Department of Planning Consent SSD-5878 Conditions

Department of Planning Consent SSD-6010 Schedule 1 - Key Issues

01 INTRODUCTION

This report has been prepared by Allen Jack and Cottier in response to the NSW Department of Planning and Infrastructure letter dated 28 November 2013. It also addresses each of the relevant issues raised in submissions made by State Government agencies and the City of Sydney. It provides additional justification and/ or clarification to particular design issues.

Figure 1 Activation Diagram - Ground

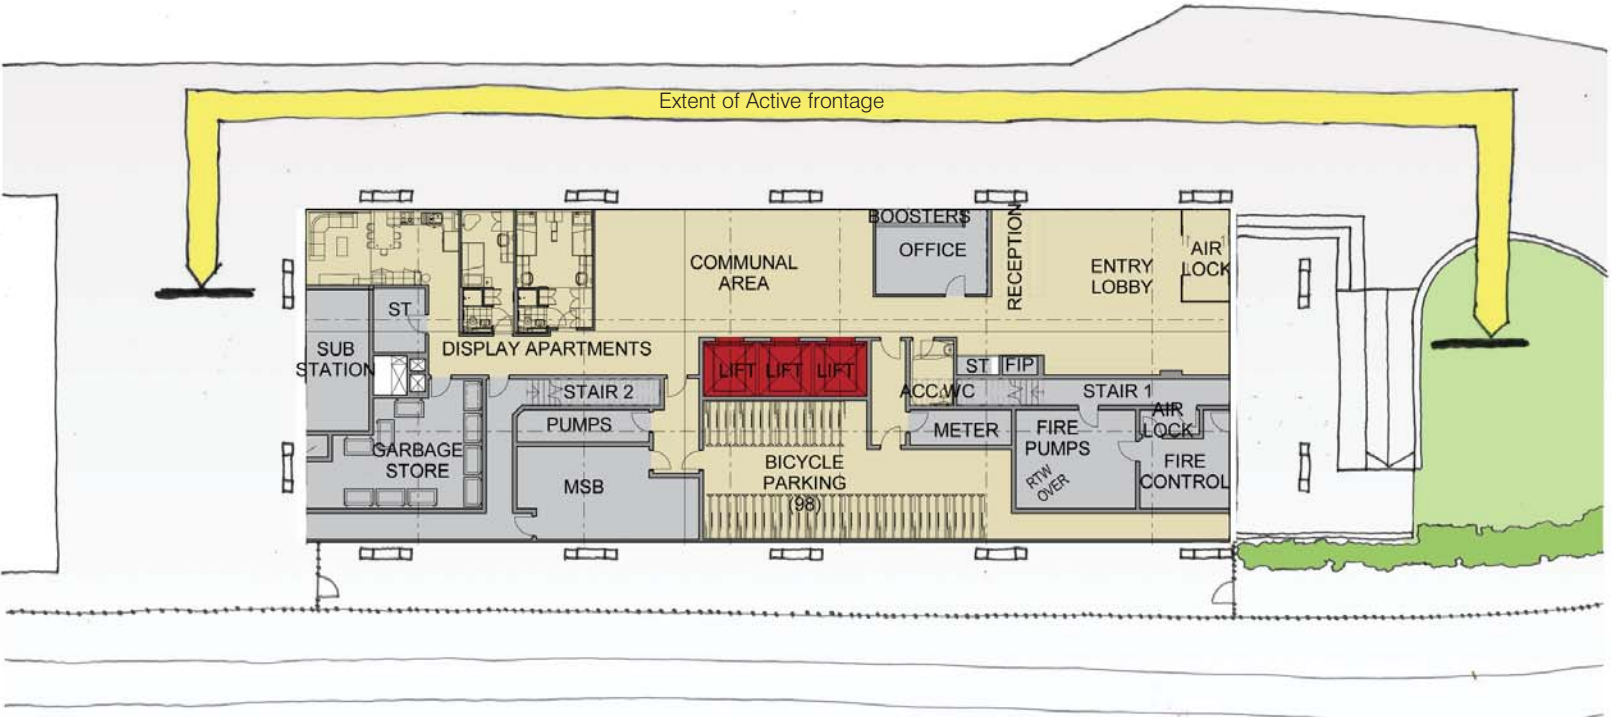
Condition B3	Response
Future Development Applications shall maximise street level activation where possible. A Street Level Activation Plan shall be provided that: a) indicates the extent and locations where street level activation has been provided; b) provides justification for the areas where street level activation has not been provided; and c) provide mitigation measures where necessary to address any inactive building facades at the street level (excluding any vehicular access points).	Ground floor street level activation has been provided to the north, east and south frontages as shown on Figures 1, 2, 3 & 4. Activation consists of building entry, lobby, reception, offices and display apartments. No activation has been provided to the ground floor western frontage as access to this area is restricted to maintenance use and the like only. This frontage faces on to the light rail corridor rather than a street and as such, activation is not required. A proportion of the ground level north and south frontages do not have street level activation, as follows: - northern: approximately two thirds of the northern elevation is not activated, containing a substation, entry to the garbage room and fire stair egress in the north-west corner. As these uses are of a functional nature and require vehicular access, it was felt appropriate to locate these away from the street frontage; and - southern: approximately half of the southern elevation is not activated, containing entry to the bike parking and fire control rooms and fire stair egress in the south-west corner. Mitigation has been provided as follows: - northern: activation of the entire first floor frontage has been provided, being the communal balcony off the kitchen/dining room and the manager's apartment; - southern: a high degree of ground floor activation is provided by the building entry and colonnade on this frontage facing Macathur Place, as well as the gym on the first floor; and - western: activation of the first floor frontage has been provided, being the manager's apartment, two residential apartments, communal laundry, games room and gym.

Figure 9 Forecast Pedestrian Traffic Routes, Urbanest Haymarket

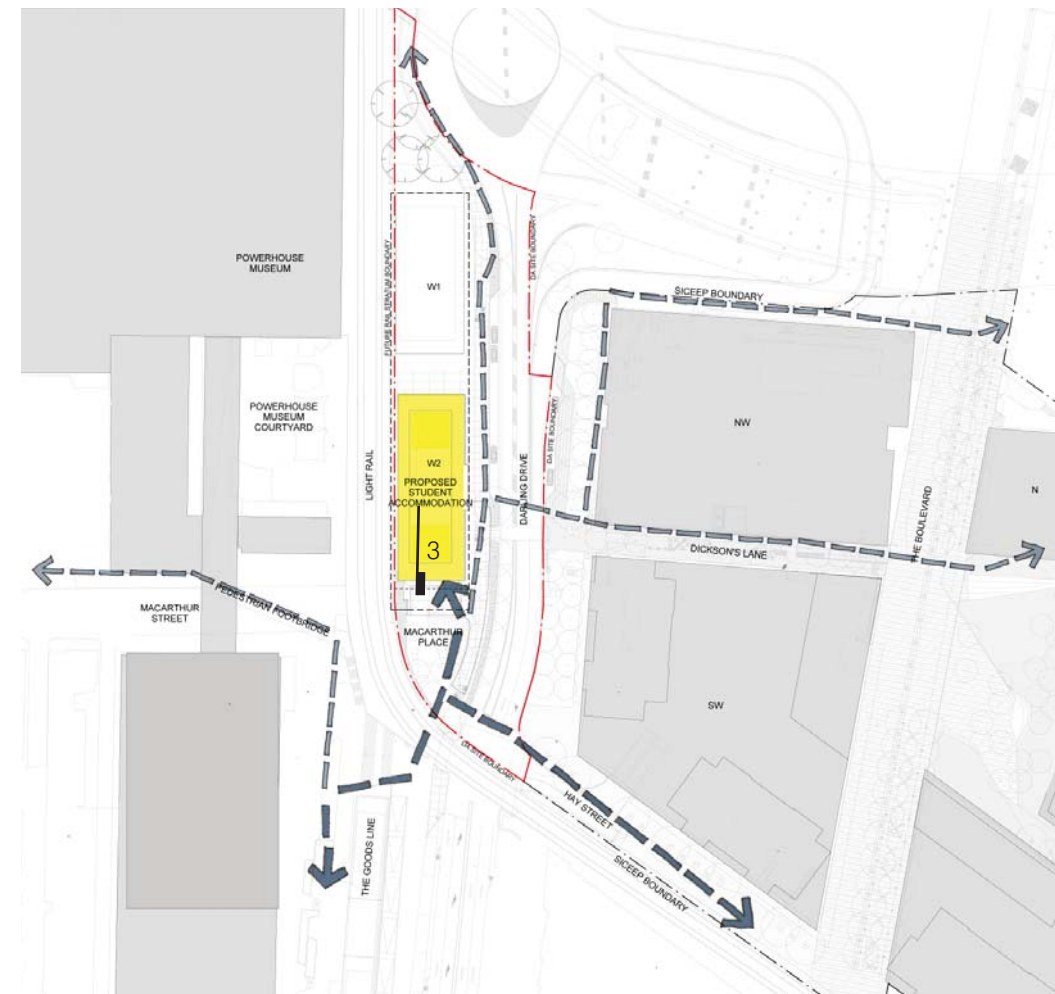
(d) Whether an awning should be provided on the eastern façade to improve pedestrian usability of this area during adverse weather conditions;	Primary pedestrian flows to/from the building will be to the main building entry on the Southern side of the site via The Goods Line, Hay St and to a lesser extent, Dicksons Lane. It is not therefore considered necessary to provide an awning along the Darling Drive frontage. Refer to Figures 9 & 10. Furthermore, wind studies submitted with SSDA2 show that street level wind conditions will be within acceptable limits in this area, thus no additional protection for pedestrians is required. See also City of Sydney recommendation 44.

Figure 9 Precedent Residential Floor to Floor Heights, Urbanest St Michaels, City Road

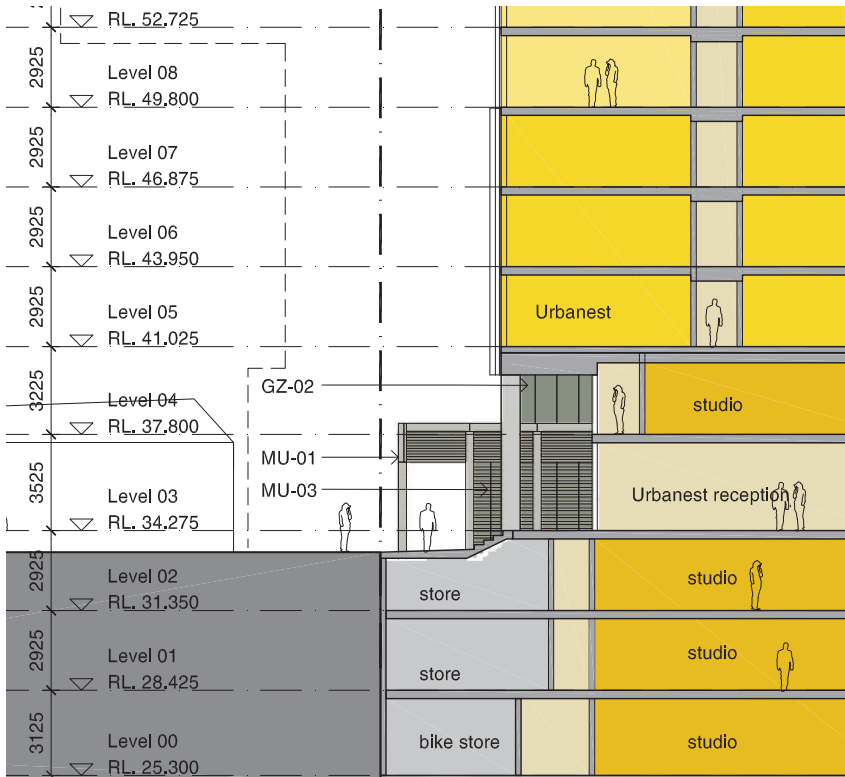
Key Issue 4	Response
Additional information is to be provided in relation to the proposed floor to floor heights of the residential component of the proposal and the proposal's compliance with the lower two levels floor heights against the Design Report as provided in the Concept Proposal application.	Ceiling height of habitable rooms is proposed to be 2.7m. This can be achieved with a floor to floor height of 2.9m with an allowance for a 200mm thick slab, which can comply with the acoustic and fire separations requirements of the BCA. Refer to Figures 9, 10 & 11. The floor-to-floor height of Ground and First floors are 4m. The 4.5m Ground level floor-to-floor height established in the Stage 1 Design Report is for retail/ mixed use buildings, whilst this building is residential. The desire for long term flexibility which is driving Council's recommendation to adopt 4.5m floor to floor on the ground level needs to be offset against the knowledge that the proposal is for a purpose built student accommodation facility. Given the nature of the use, the building's ground floor is taken up by functional student accommodation common amenities. The design does not preclude the building being utilised for adaptive reuse in the future.

Figure 15 Security fence plan

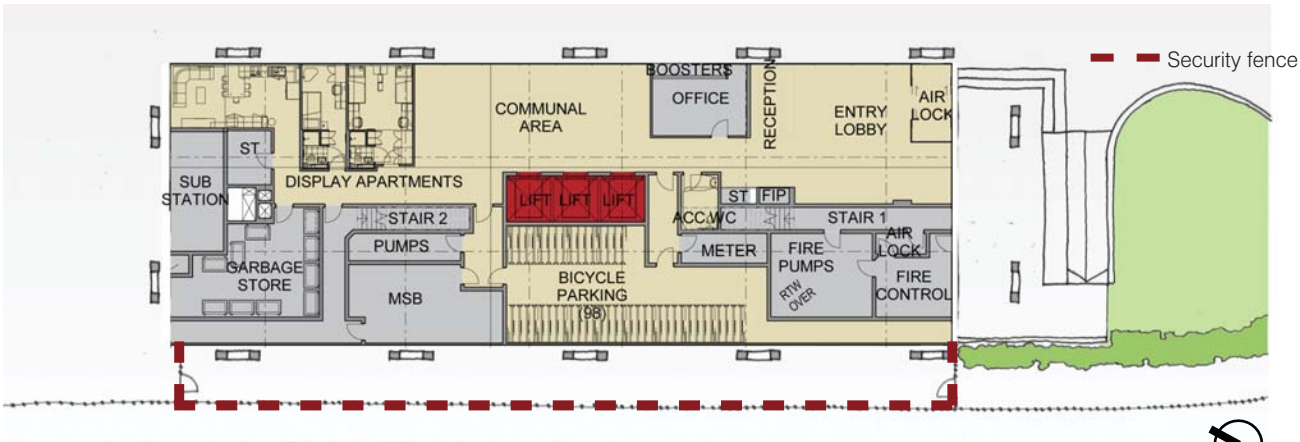
Key Issue 9	Response
Details are to be provided in relation to the treatment of the western boundary fencing and security measures.	The fencing design is subject to approval by Transport for NSW. The fencing height is proposed as 1.5m, and the palette of materials envisaged is dark coloured steel framed PVC coated chain mesh and/or expanded metal mesh. This is unobtrusive and will allow views through, whilst complying with the requisite safety standards. Refer to Figures 13, 14 & 15.

Figure 16 Forecast Pedestrian Traffic Routes, Urbanest Haymarket

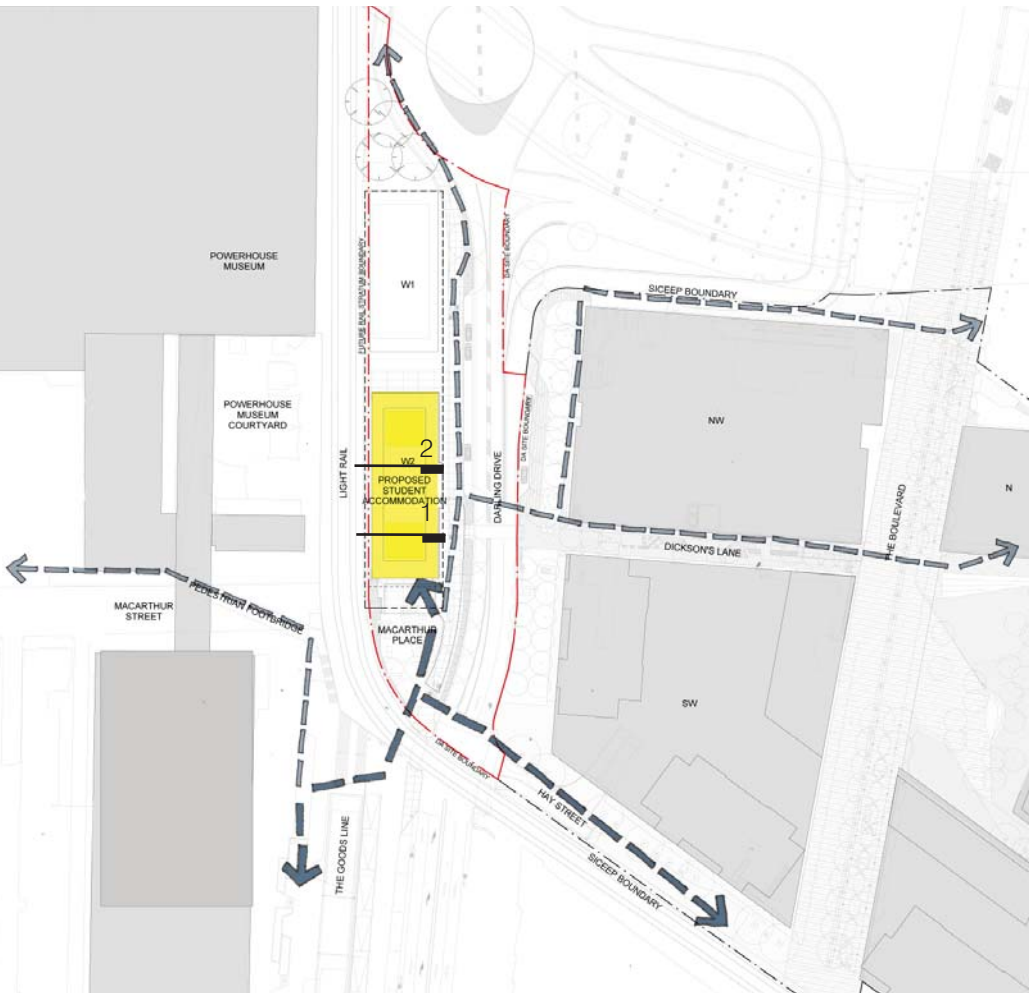
COUNCIL	RESPONSE
Provide a ground level colonnade to Darling Drive. Ensure that the northern and eastern colonnades: - are continuous around the northern, eastern and southern facades of the building; - have a minimum depth of 3m to the southern and eastern facades; and - provide weather protection for pedestrians and mitigate wind effects from the tower above.	The main entry is at the southern end of the building; a 4m deep colonnade is proposed at this point to mark the entry and provide a threshold space between the public realm and the building's interior. There is also a service entry at the northern end of the building; a 2.4m deep colonnade is proposed at this point to provide covered access to this entry. There are no entries along the eastern or western sides of the building, therefore; the colonnades along these sides are 1 to 1.5m deep to give definition to the lower floors of the building and create a pedestrian level environment that relates to the podium height of the other buildings in the Haymarket precinct. Refer to Figures 5 and 6. The proportions of the lot are such that provision of a 3m deep colonnade along the east and west sides of the building would severely compromise floor space on the ground and first floors. Taking into account the double height colonnade to the east, any awning projection over the footpath would be of very little benefit given it would be +8m above ground. Primary pedestrian flows to/from the building will be to the main building entry on the Southern side of the site via The Goods Line, Hay St and to a lesser extent, Dicksons Lane. Refer to Figure 14. It is not considered necessary to provide a deeper colonnade along the Darling Drive frontage; furthermore, wind studies submitted with SSDA2 show that street level wind conditions will be within acceptable limits in this area, thus no additional protection for pedestrians is required.
